Application no: H08-0238-10

Description: Details of south and east boundaries and boundary treatment, site levels, external boxes, eaves, verges, chimney stacks etc, sash windows and window frames, external doors and external materials (Conditions 4, 5, 6, 8, 9, 10, 11, 12 and 14 of H08-0803-09)

Amendment: Amended details to Condition 5 and part Condition 10
(Dwg. no. 1701-12B)

Condition Compliance Details

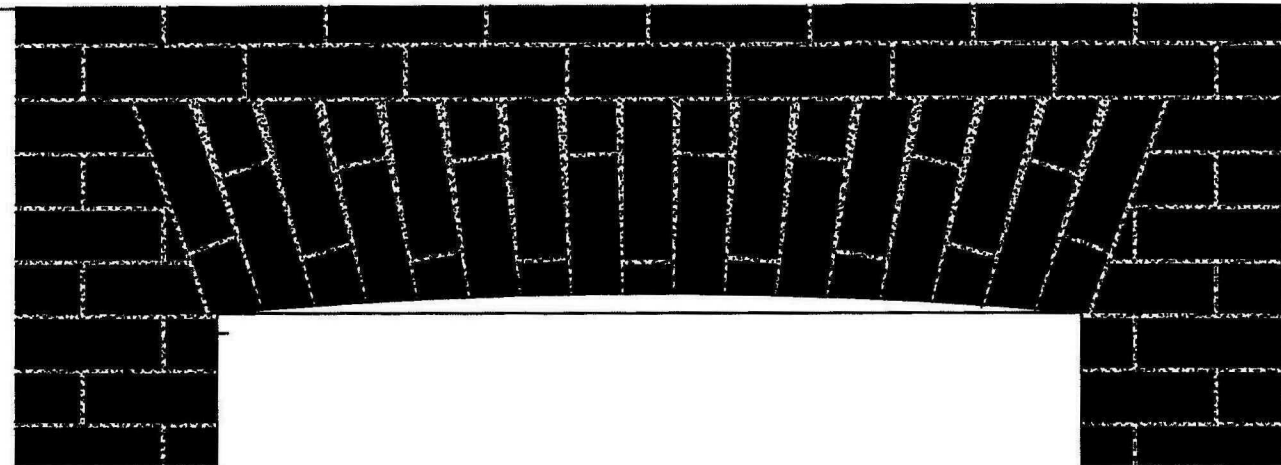
- **Condition 5**

All boundaries to have 1100mm high Timber Post and Rail fencing with a mixture of New Beech / Girselinia / Littoralis hedging planted inside of fencing

The southern boundary will have Wrought Iron Estate Fencing and field gates as shown on pictures below:

Both stand 1.15m tall approx. The 50 x 12mm posts are spaced at 1m centres and have 5 traditionally spaced 20mm solid round rails (small gap nearer the ground with each spacing becoming greater as they rise up the fence) and finished in a black paint.

AMENDED PLAN
Ref. A2

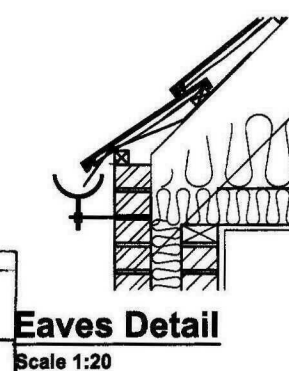
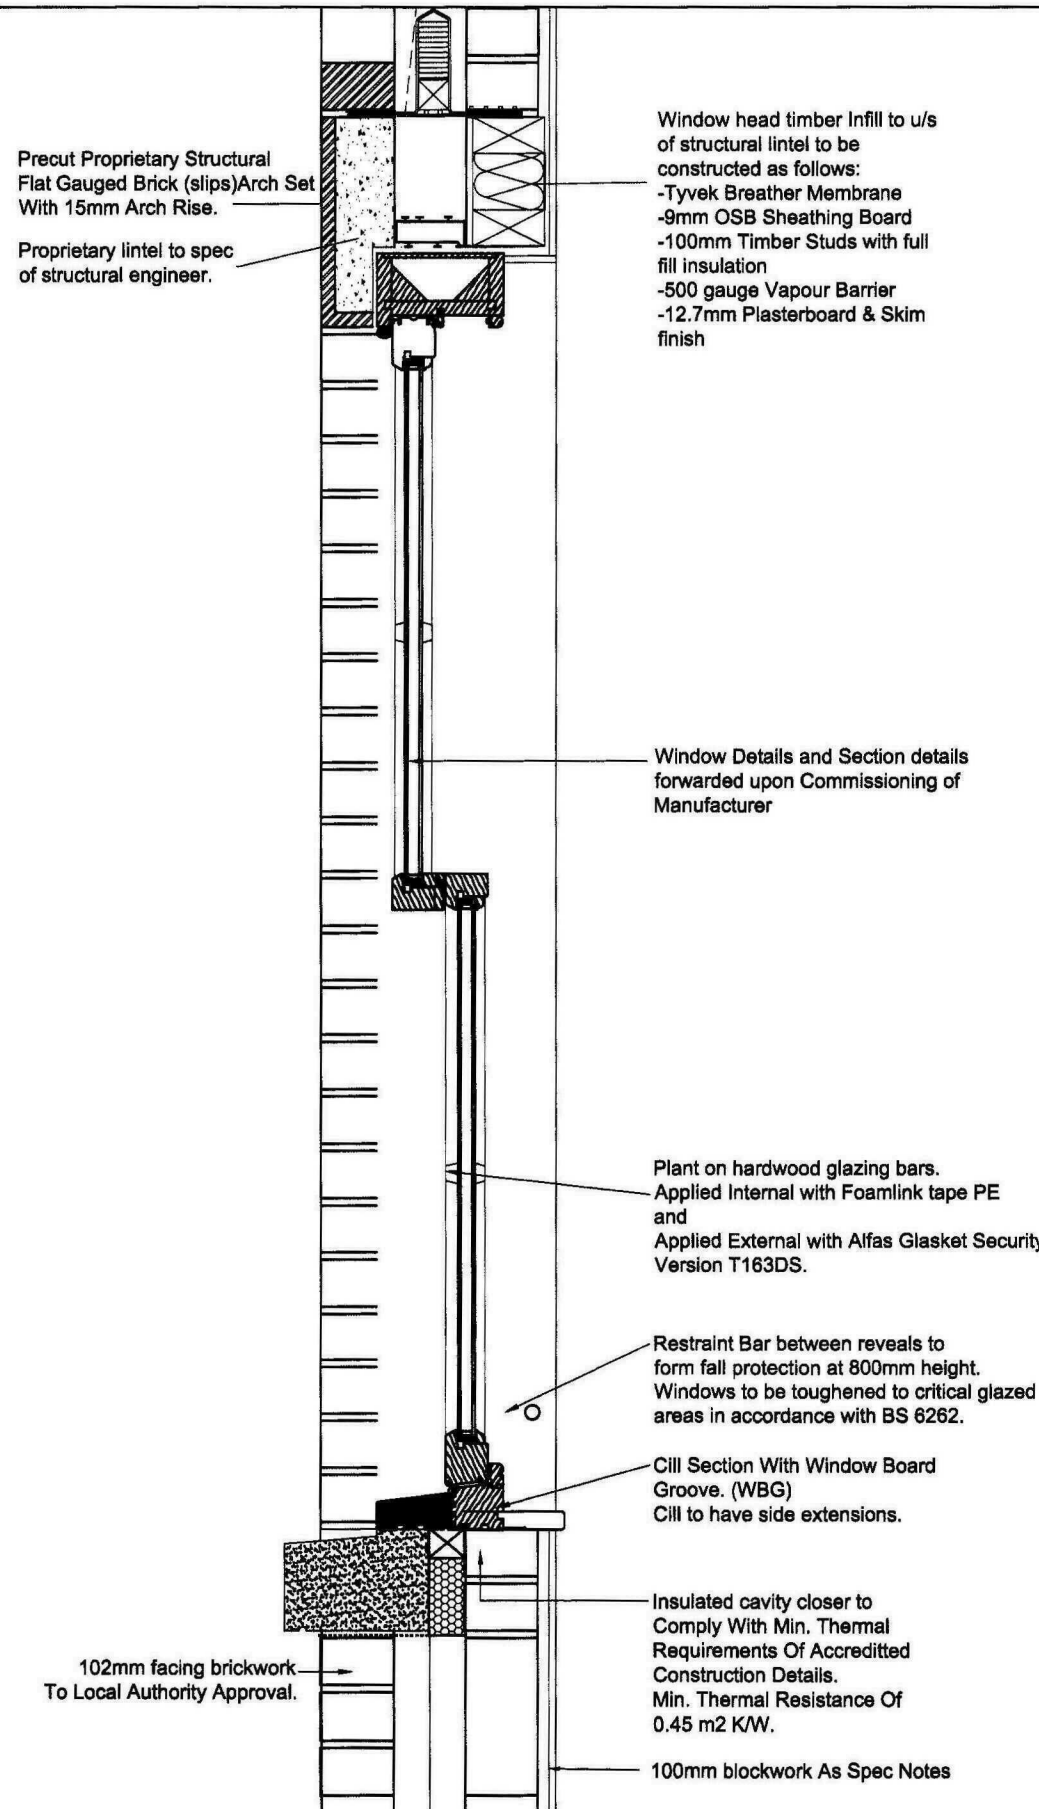
rev B - 18.09.10 - Window Details amended
rev A - 02.06.10 - General Planning Amendments

Prescut Proprietary Structural
Flat Gauged Brick (slips) Arch Set
With 15mm Arch Rise.
Proprietary lintel to spec
of structural engineer.

Window head timber infill to u/s
of structural lintel to be
constructed as follows:
-Tyvek Breather Membrane
-9mm OSB Sheathing Board
-100mm Timber Studs with full
fill insulation
-500 gauge Vapour Barrier
-12.7mm Plasterboard & Skim
finish

Plant on hardwood glazing bars.
Applied Internal with Foamlink tape PE
and
Applied External with Alfes Gasket Security
Version T163DS.

Restraint Bar between reveals to
form fall protection at 800mm height.
Windows to be toughened to critical glazed
areas in accordance with BS 6262.

Cill Section With Window Board
Groove. (WSG)
Cill to have side extensions.

Insulated cavity closer to
Comply With Min. Thermal
Requirements Of Accredited
Construction Details.
Min. Thermal Resistance Of
0.45 m2 KW.
